<b>Relocation of Wire on Replacement VFDs</b>		TSB 2012010
Created/Last Revised Date 11/09/2012	Last Reviewed Date 11/09/2012	Page 1 of 1

**TECHNICAL SERVICE BULLETIN**

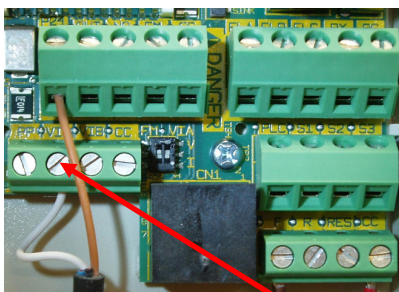
The manufacturer discontinued the model of the VFD used in Better Water LLC's 3046 ROs and Post-treatment devices in October of 2012. The replacement model is functionally the same with the exception of the use of one of the terminal posts and the location of grounding posts, both requiring the relocation of wires if the old model VFD is replaced with the new model.

Better Water LLC's part number of **EQMOBO01350** which is the "3 Phase-In / 3 Phase-Out / 5 Horsepower VFD" will remain the same. The difference between these two models is mostly cosmetic. See the pictures below of the old and new models.

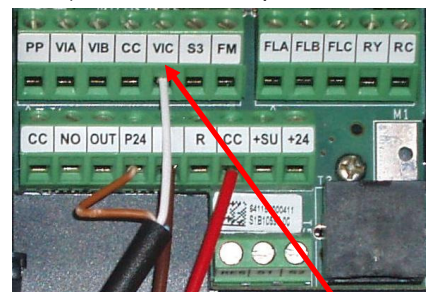
1. Turn off the power, and unplug the device from the electrical outlet before opening the control box.
2. On the old model VFD, take note of the location of the **wire (from the pressure transducer) on the terminal post labeled VIA** and where the **three ground wires** are located.
3. Replace the old model VFD with the new model VFD, reconnecting the wires with the following exceptions.
4. On the new model VFD, relocate the wire (from the pressure transducer) to the terminal post labeled **VIC**.

**Old Model VFD**  
Wire located on terminal post VIA

**New Model VFD**  
Wire located on terminal post VIC

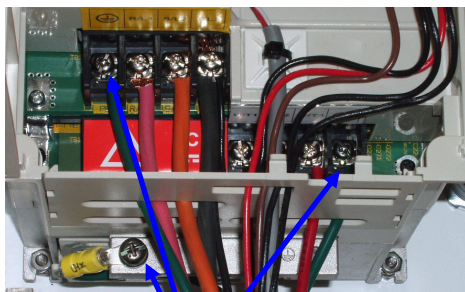
5. Relocate the three ground wires to the three grounding posts on the bottom of the new model VFD.

**Old Model VFD**  
Three ground wires

**New Model VFD**  
Three grounding posts
